Technical Service Bulletin: TSB200140

Released Date: 18-Dec-2025

Low Pressure Gear Pump and Lines

Figure 21, Existing Inlet Line, Part Number 2897186 (Green), Existing Gear Pump Part Number 5461704 (Blue), Fuel Filter Arrangement (White)

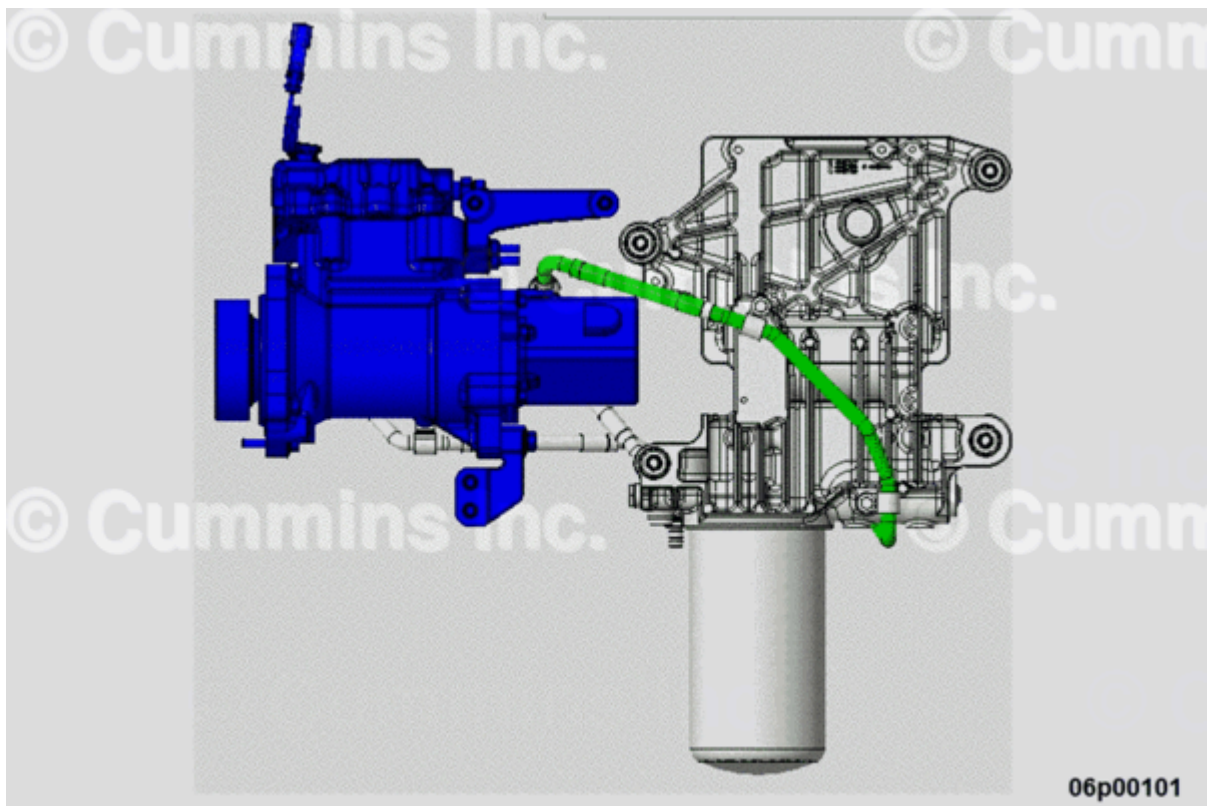
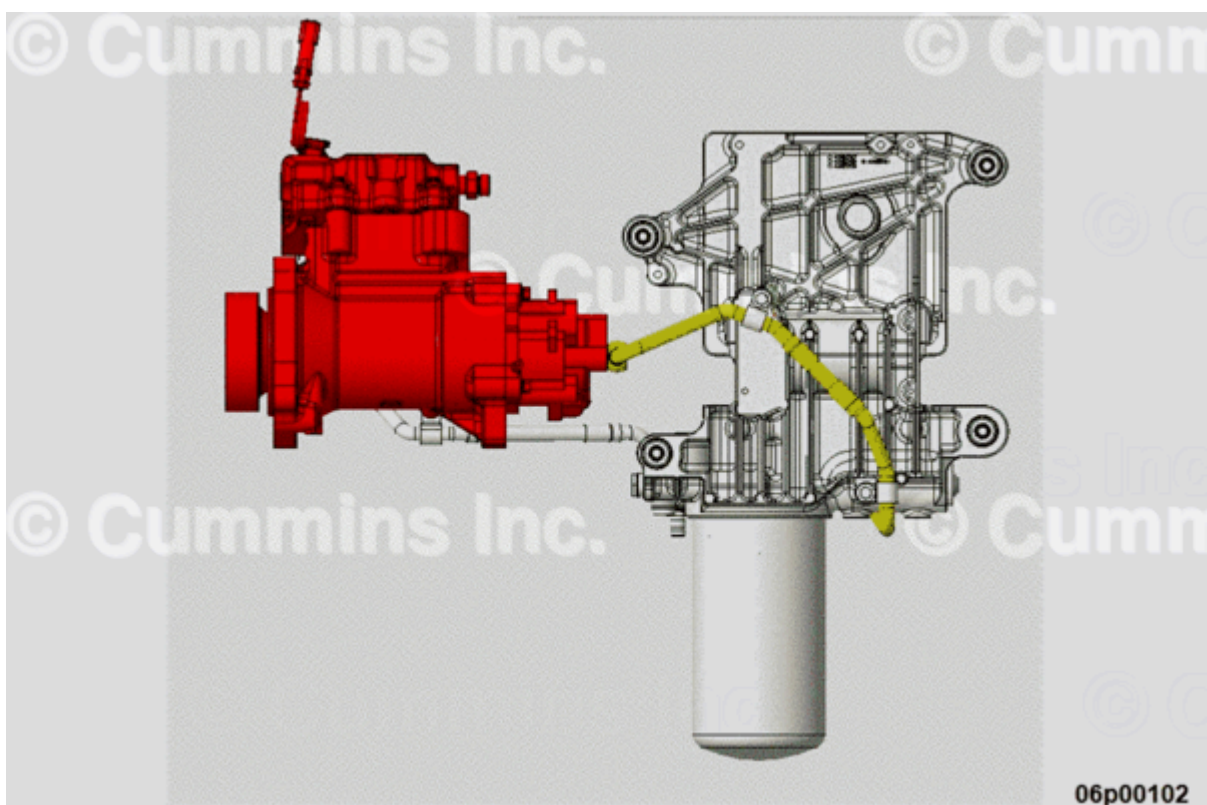
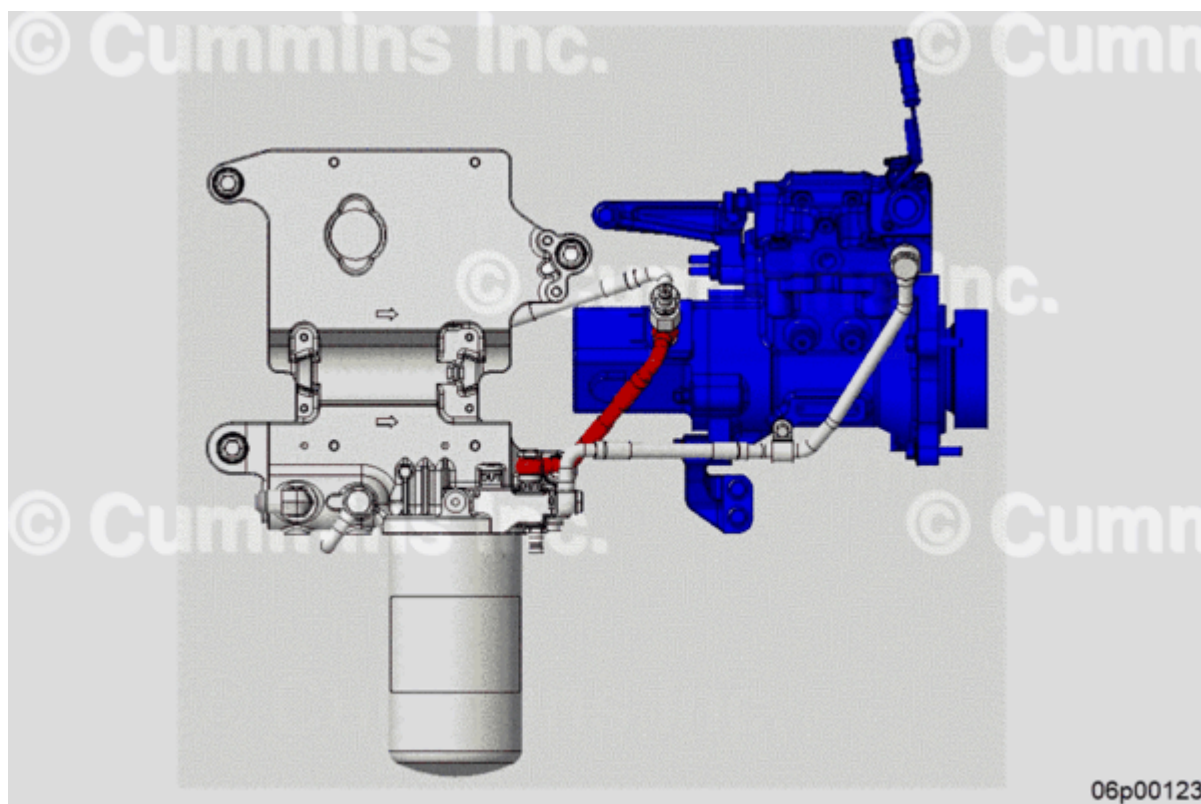
Figure 22, New Inlet Line, Part Number 5479011 (Yellow), New Gear Pump, Part Number 5491783 (Red), Fuel Filter Arrangement (White)

Figure 25, Existing Outlet Line, Part Number 2899698 (Red), Existing Gear Pump, Part Number 5461704 (Blue), Fuel Filter Arrangement (White)

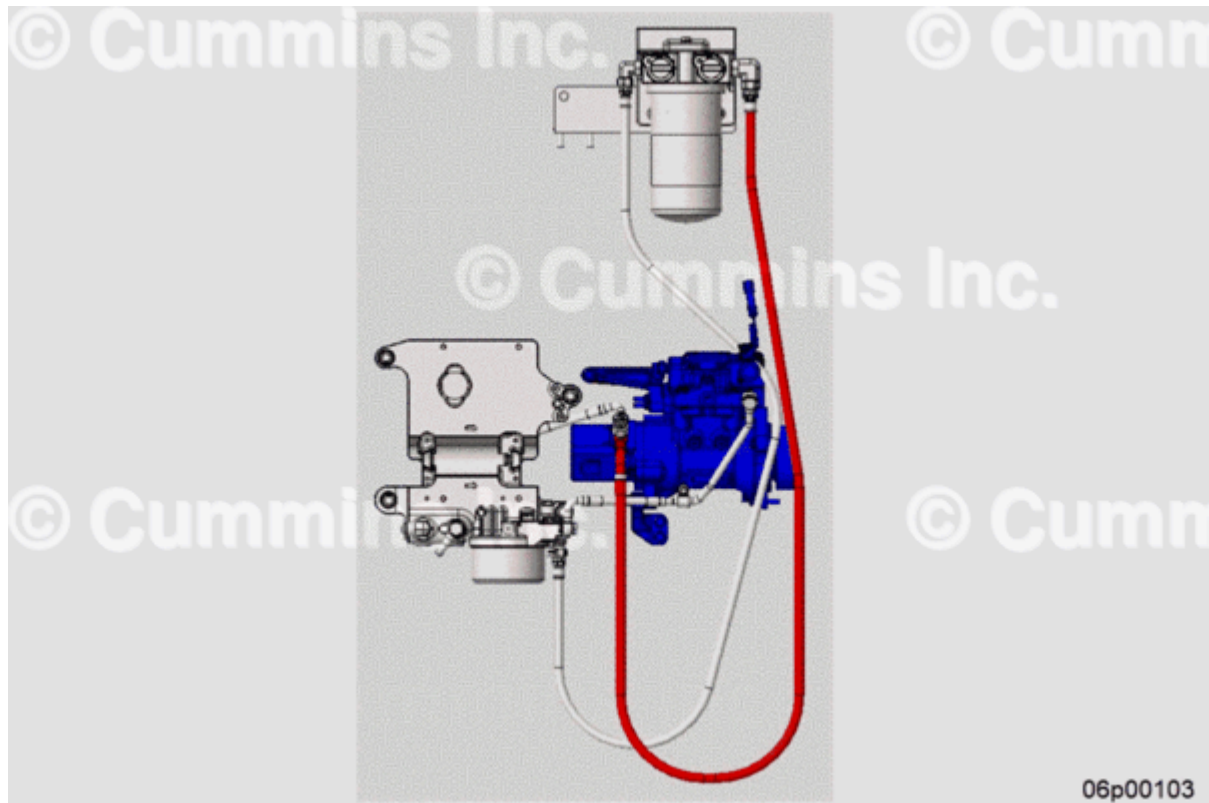
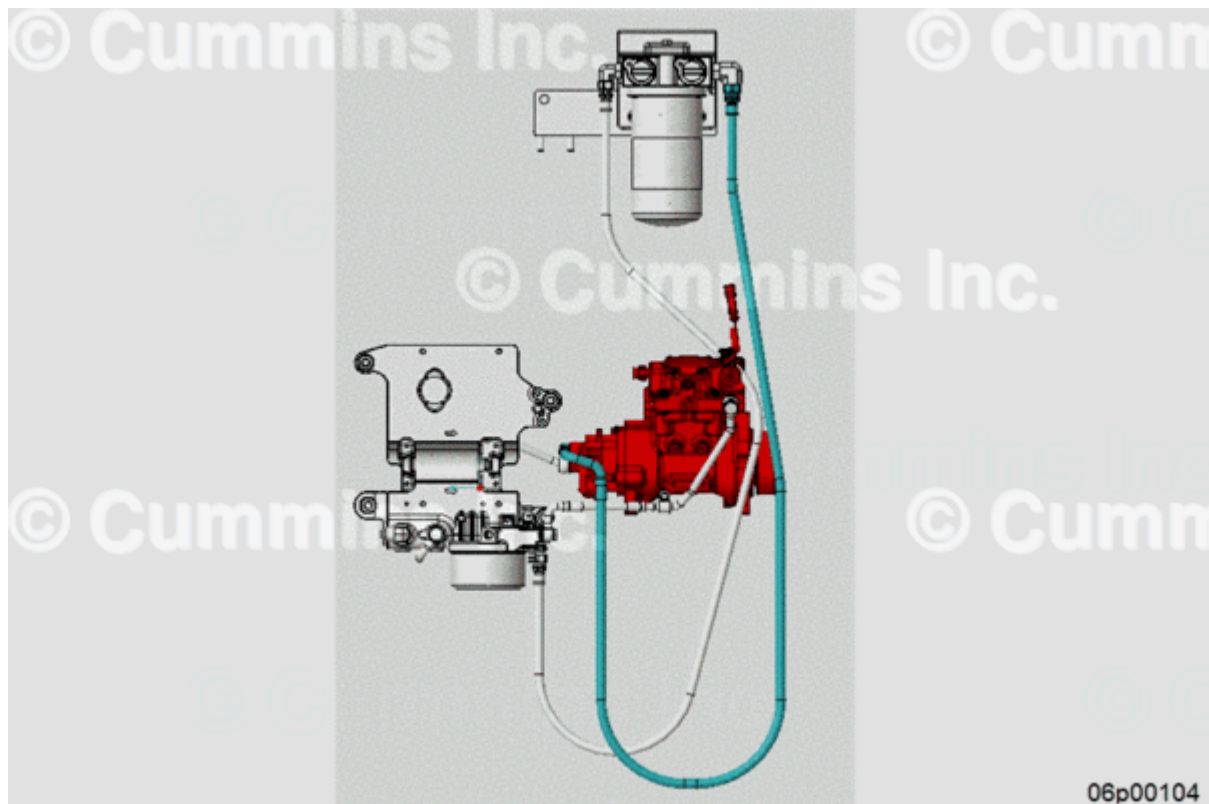
Figure 26, New Outlet Line, Part Number 5479013 (Teal), New Gear Pump, Part Number 5491783 (Red), Fuel Filter Arrangement (White)
